# Access Compliance Report

## Public Rights-of-Way

### (Curb Ramps)

Intersection ID: 9487	Main Street: ARDEN_ST	Cross Street: KOHLER_AV	Location: NW
ADA ID: 209021370448	Ramp Type: Para	Initial Pass/Fail: Fail	Overall Compliance: No
Severity Score: 13.75			
Codes/Mitigation Info/Possible Solution		Field Measurements/Component Compliance

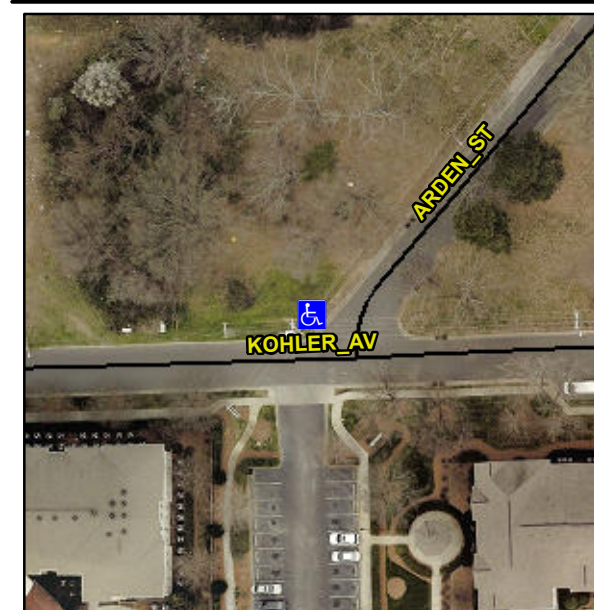
**CURB GAP 1.0**

**R304.3.2, R304.5.3**

Compliance	Description	Data	Compliance	Description	Data
N/A	Ramp Length LT (in)	N/A	N/A	Ramp Length RT (in)	67.0
N/A	Ramp Width LT (in)	N/A	Yes	Ramp Width RT (in)	59.0
N/A	Ramp Slope LT (%)	N/A	No	Ramp Slope RT (%)	10.7
N/A	Ramp XSlope LT (%)	N/A	No	Ramp XSlope RT (%)	3.4
N/A	Landing Length (in)	N/A	N/A	DWS Provided?	N/A
N/A	Landing Width (in)	N/A	N/A	DWS Contrast?	N/A
N/A	Landing Slope (%)	N/A	N/A	DWS Length (in)	N/A
N/A	Landing X Slope (%)	N/A	N/A	DWS Full Width?	N/A
N/A	Landing Curb? (Y/N)	N/A	N/A	DWS Offset (in)	N/A
N/A	Shared Landing?	N/A			
N/A	Gutter Ponding?	N/A	N/A	Gutter Slope (%)	N/A
N/A	Gutter Lip Ht (in)	N/A	N/A	Gutter X Slope (%)	N/A
N/A	Painted X Walk1?	No	N/A	Painted X Walk2?	N/A
	X Walk 1 Direction	To S		X Walk 2 Direction	N/A
N/A	X Walk 1 Width (in)	N/A	N/A	X Walk 2 Width (in)	N/A
	X Walk 1 Slope (%)	1.5		X Walk 2 Slope (%)	N/A
	X Walk 1 X Slope (%)	2.6		X Walk 2 X Slope (%)	N/A
N/A	Ramp inside XWalk1?	N/A	N/A	Ramp inside XWalk2?	N/A

**Remove & Replace Entire Ramp.**
